UNITED STATES PATENT AND TRADEMARK OFFICE

APPLICATION NO.	FILING DATE	FIRST NAMED INVENTOR	ATTORNEY DOCKET NO.	CONFIRMATION NO.
10/674,731	09/30/2003	Raymond R. Price	R15-004-02-US	3975

Office Action Summary

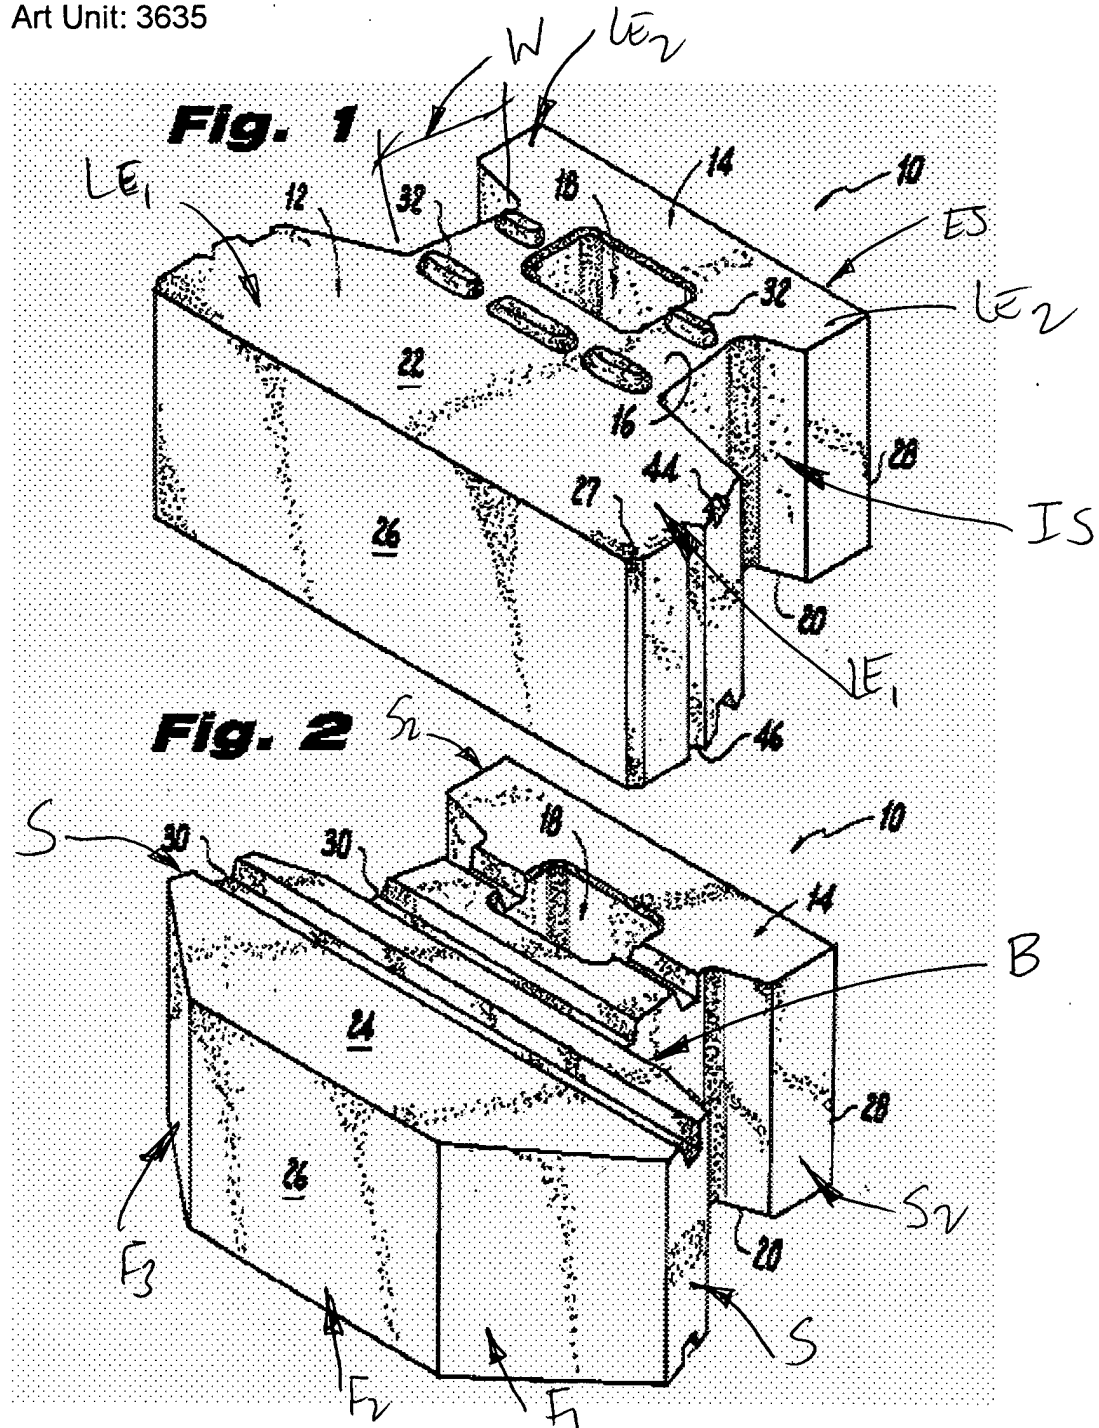
Claims 1-34 are rejected under 35 U.S.C. 102(b) as being anticipated by US Patent #5,951,210 to MAGUIRE et al. Regarding claims 1,2,10 and 23, MAGUIRE et al. discloses the use of a preformed horizontally elongate block (10) including a front (26), a rear (28), first and second sides (S), see the marked figure below, a top (22) and a bottom (24); the front (26) of the block comprising a viewable surface and a back surface (B), see the marked figure below; a projection (32) extending outwardly from the block top (22); and the

block (10) defining a recess (30) at the bottom (24) from the location of the projection, the recess (30) extending transversely and continuously across the block, the recess (30) comprising a stop surface (the sides of the channel) that is coplanar with the back surface of the front, wherein the recess (30) of the horizontally elongated block permits

the projection (32) of a second block (10) to engage the back surface (B) of the front (26) of the horizontally elongated block (10). In reference to claim 2, the front (26) and rear (28) portions of MAGUIRE et al. further includes lateral extents (LE1) and (LE2); respectively, see the marked attachment above. The front (26) and rear members (28) are connected by a web (W), see also the marked figure above, wherein the recess (30) extends transversely across the bottom (24); and the rear portion (28) includes an interior surface (IS), an exterior surface (ES), and sides (S2), see the marked attachment above. Regarding claims 3,6,13,16,25 and 28, the projection (32) comprises an indexing surface (the sides of the projection) and the recess (30) comprises a stop surface (the bottom of the recess), with the indexing and stop surfaces of the blocks in vertical alignment with each other, figure 6, and with the indexing and stop surfaces serving to position the block in one course in a predetermined relation with another block (10) in an adjacent course as the indexing and stop surfaces of adjacent courses of blocks (10) are brought into registry with each other. In reference to claims 4,5,14,15,26,27 and 31, the indexing and stop surfaces are offset by a first predetermined distance (the distance between the rear surface (B) of the front (26) and interior (IS) of the back (28)) and by a plurality of predetermined distances (the first predetermined distance on both sides of the block). Regarding claim 7,17, and 29 the predetermined relation is coplanar when the blocks (10) are arranged in a straight configuration. In reference to claim 8,18, and 30 the predetermined configuration is offset when the blocks (10) form an arcuate configuration. Further regarding claim 10, when the blocks (10) are stacked one upon the other, see figures 5 and 6, the stop (the
